# DEVELOPMENT REVIEW BOARD REPORT

CASE NUMBER/ PROJECT NAME	<b>102-DR-2005</b> <b>El Paseo-Retail Center</b>		
LOCATION	North East Corner of N. 68 <sup>th</sup> Street and E. Camelback Road		
REQUEST	Request approval for a site plan and elevations for a new neighborhood retail center.		
OWNER	Bullington Trust	ENGINEER	CMX Group Inc. 602-567-1900
ARCHITECT/ DESIGNER	Larry Ellermann Ellermann, Schick & Bruno 602-266-6202	APPLICANT/ COORDINATOR	Larry Ellerman Ellermann, Schick & Bruno 602-266-6202
BACKGROUND	<p><b>Zoning.</b></p> <p>The site is zoned Downtown Regional Commercial Office, Type 2, Planned Block Development, Downtown Overlay Planned Block Development (D/RCO-2/DO PBD). The D/RCO-2/DO PBD zone allows for a variety of uses, including commercial retail, office, and restaurant uses. The Downtown zoning is generally the most intense zoning district in the City.</p> <p><b>Context.</b></p> <p>The site is located at the northeast corner of N. 68<sup>th</sup> Street and E. Camelback Road. It was originally part of a horse ranch owned by the applicant's family and has been subdivided slowly over time. This is the last undeveloped parcel at the location.</p> <p>Adjacent Uses:</p> <u

### SITE PLAN

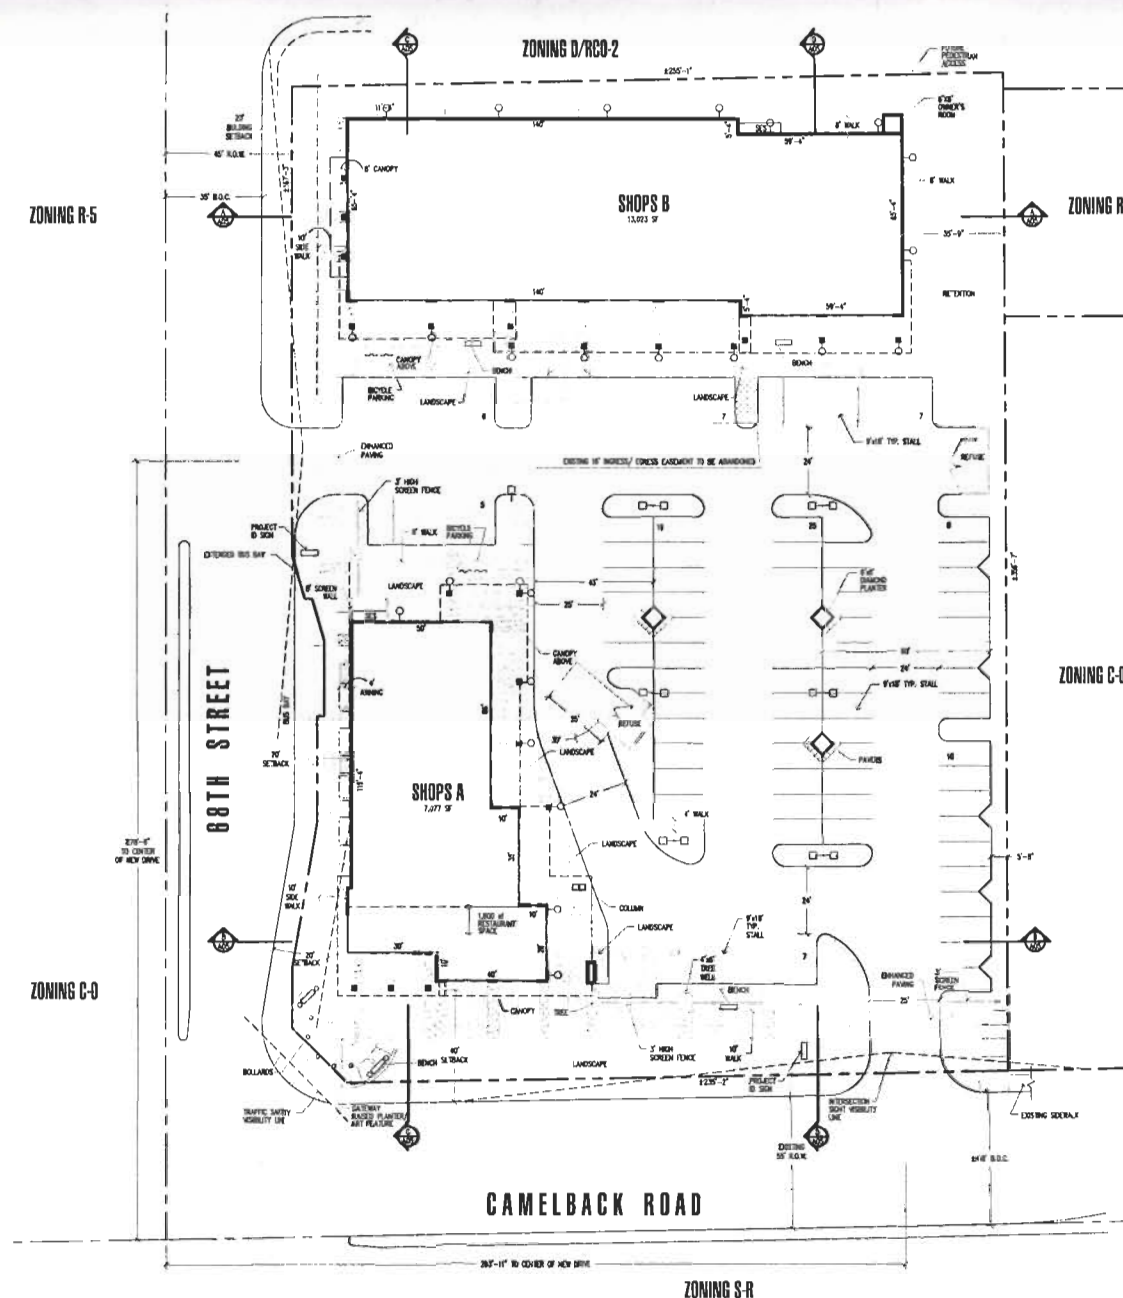
The site plan orients the Shops A building toward N. 68<sup>th</sup> Street, with a small projection along E. Camelback Road to allow some amount of street presence. The main bulk of the view corridor along E. Camelback Road, however, will be the parking lot with the Shops B structure located to the rear of the site. All access to the various retail shops will be internal to the site plan. There will not be access to the various retail shops from N. 68<sup>th</sup> Street.

- b. The location and configuration of all site improvements shall be constructed to be consistent with the site plan submitted by Ellermann, Schick & Bruno Architecture Planning with a city receipt date of 1/5/2006.

14. *The proposed 6 X 6 diamond planters shown within the parking lot shall be replaced with standard parking lot islands and be provided for every 10 parking spaces. The landscape provided in those planters shall match the landscape proposed in the northerly and southerly planters in the parking lot.*
15. Upon removal of the salvageable native plants the salvage contractor shall submit completed Native Plant Tracking Form as well as a list identifying the tag numbers of the plants surviving salvage operations to the City's Inspection Services Unit within 3 months from the beginning of salvage operations and/or prior to the issuance of the Certificate of Occupancy.

**building B - ELEVATIONS**

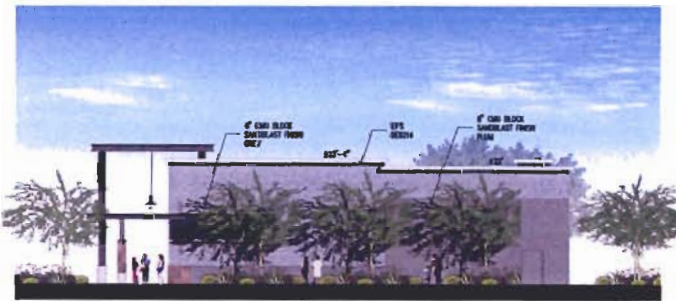
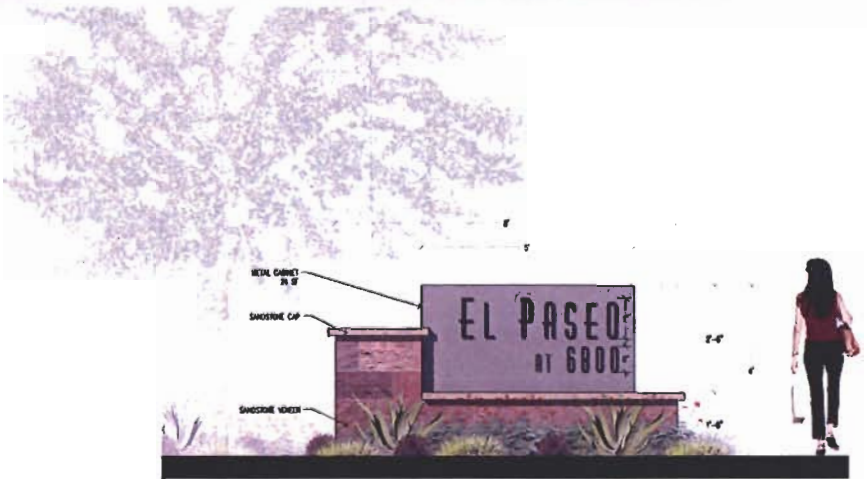
The Shops B building, while continuing many of the architectural themes of the project, has a larger canopy fronting the structure, and is central to the south facing elevation (Visible from E. Camelback Road).

The applicant is proposing an aluminum/metal storefront with glass at the front of the structure. The Downtown Design guidelines discourage this type of treatment. As such, staff has added a stipulation that the storefronts themselves must have a low wainscot treatment. The applicant would like to deviate from this requirement, and will address their concerns at the Board meeting.

3. *All storefronts must be revised to have a minimum 3 foot tall wainscot constructed of a material to match the existing center to the satisfaction of the Project Coordinator. None shall be constructed of aluminum and glass below 3 feet to the ground.*

4. *The canopy on the west elevation for Shops B shall be extended to cover the sidewalk width.*
5. The face of any service entrance section(s) shall be completely screened by a wall and painted to match the building. This area shall further be landscaped and screen the wall to the satisfaction of the Project Coordinator.
